SERVICE BULLETIN

NUMBER: SB 500-31-008, REV B
MODEL: ECLIPSE EA500
SUBJECT: DIAGNOSTIC STORAGE UNIT (DSU) ELECTRICAL CONNECTOR UPGRADE

Figure 1

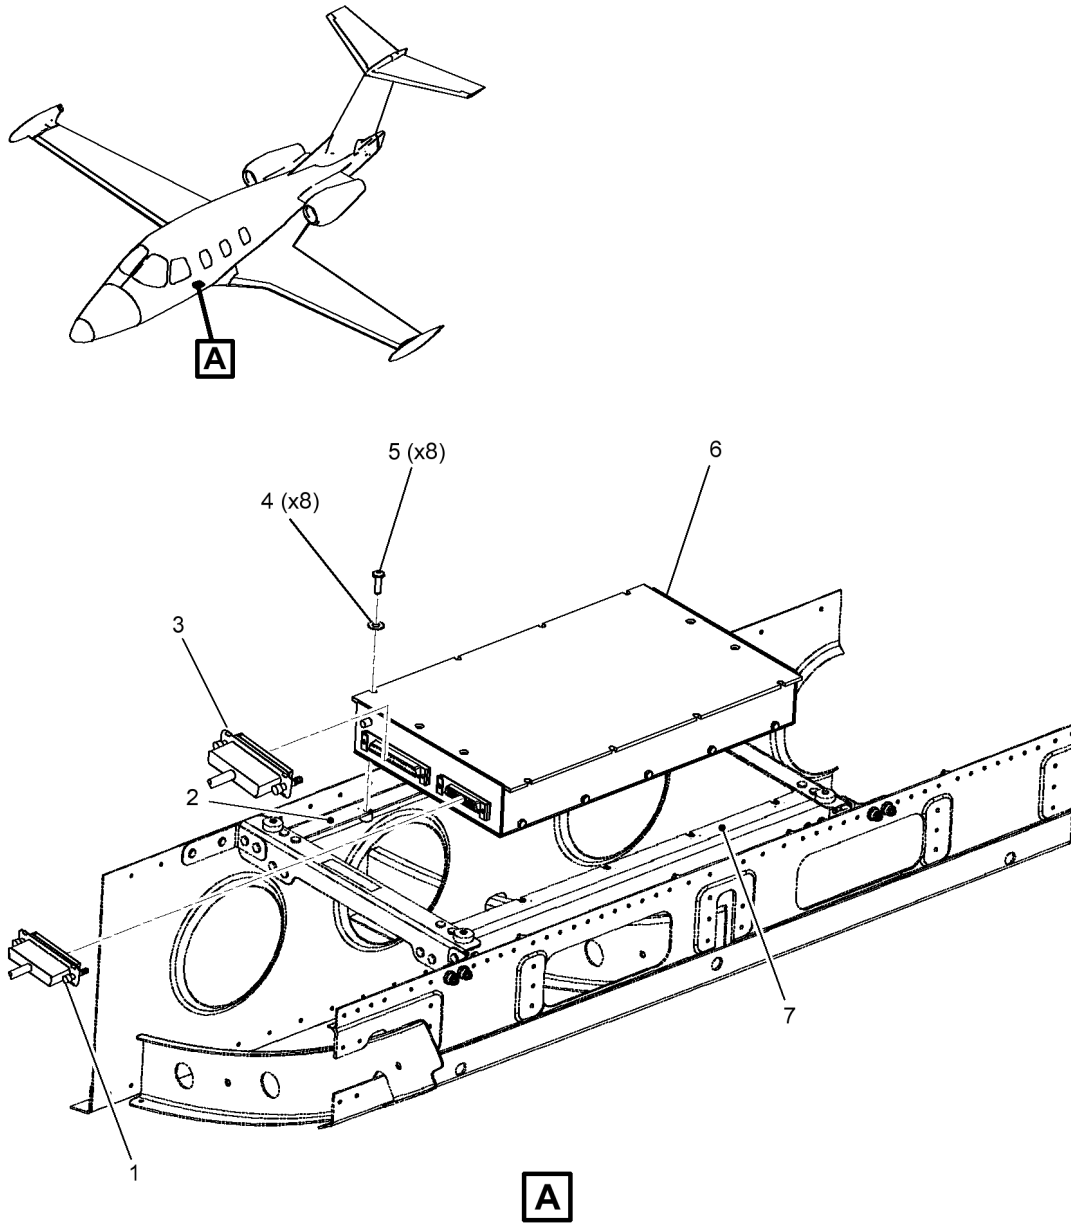
- (7) Disconnect the electrical connectors 39A10P01 and 39A10P02 (1, Figure 1) and (3, Figure 1) from the DSU (6, Figure 1).
- (8) Remove the eight bolts (5, Figure 1) and washers (3, Figure 1) that attach the DSU (6, Figure 1) to the rails (2, Figure 1) and (7, Figure 1).

- (9) Remove the DSU (6, Figure 1) from the rails (2, Figure 1) and (7, Figure 1).
- (10) Remove and discard the attachment hardware (1, Figure 3) from the harness connectors at 39A10P01 and 39A10P02.

Figure 2 (Sheet 1 of 1)

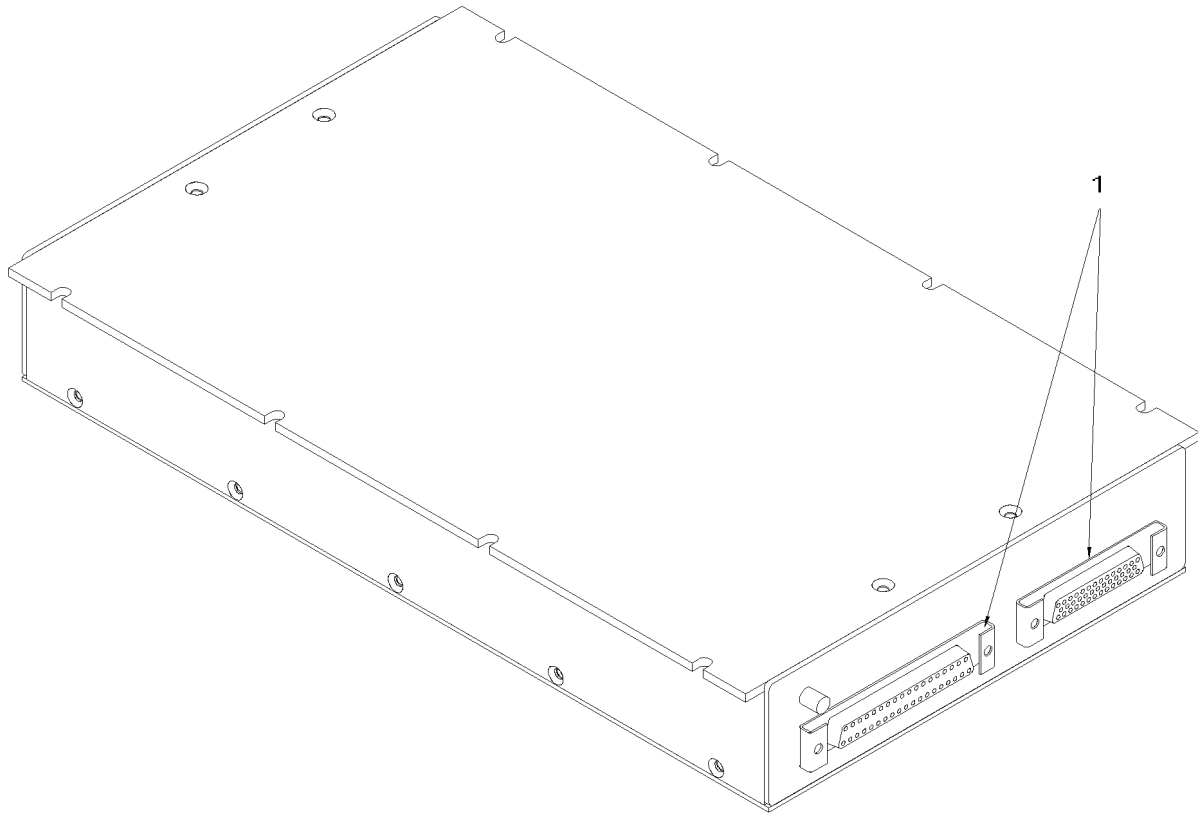
- (11) Attach the locking hardware (5, Figure 4), one on each side of the connector on 39A10P01 (4, Figure 4) and 39A10P02 (6, Figure 4).
- (12) Remove and discard the DSUB locking clips (1, Figure 2) from DSU connectors 39A10J01 and 39A10J02.

Figure 4

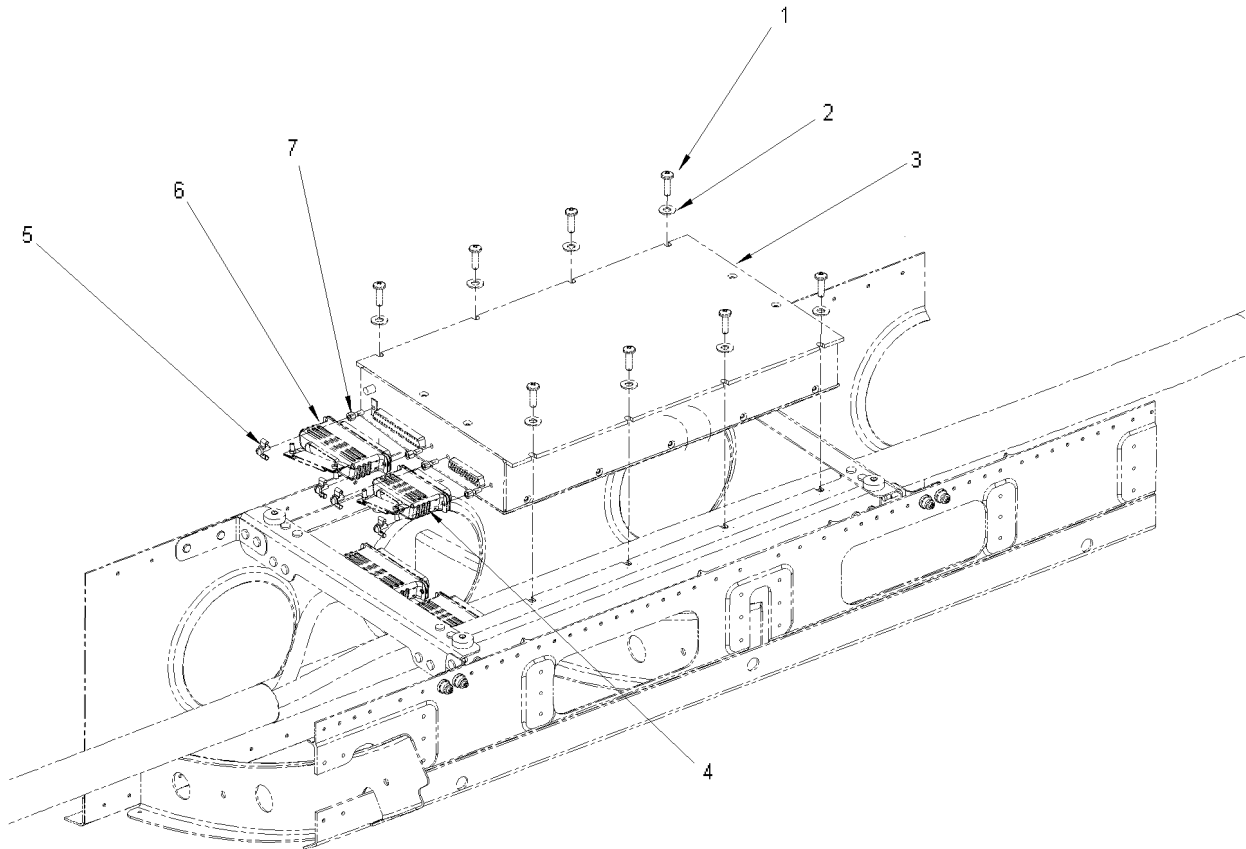
- (13) Install the Amplimite 5748270–2 Screwlocks (7, Figure 4), one on each side of the connector with 222MS Locktite on DSU connectors 39A10J01 (4, Figure 4) and 39A10J02 (6, Figure 4). Torque the Screwlocks to 6 in.lbs.

NOTE: Do not use washers with the Amplimite 5748270–2 Screwlocks.
- (14) Put the DSU (3, Figure 4) on the rails and align holes.
- (15) Attach the DSU (3, Figure 4) to the rails and with eight bolts (1, Figure 4) and washers (2, Figure 4). Torque the eight bolts (1, Figure 4) to 30-40 lbf.in (3,4-4,5 m.N).

- (16) Connect the electrical connectors 39A10P01 (6, Figure 4) and 39A10P02 (6, Figure 4) and to the DSU (3, Figure 4). Torque the screws (5, Figure 4) to 4 in.lbs.
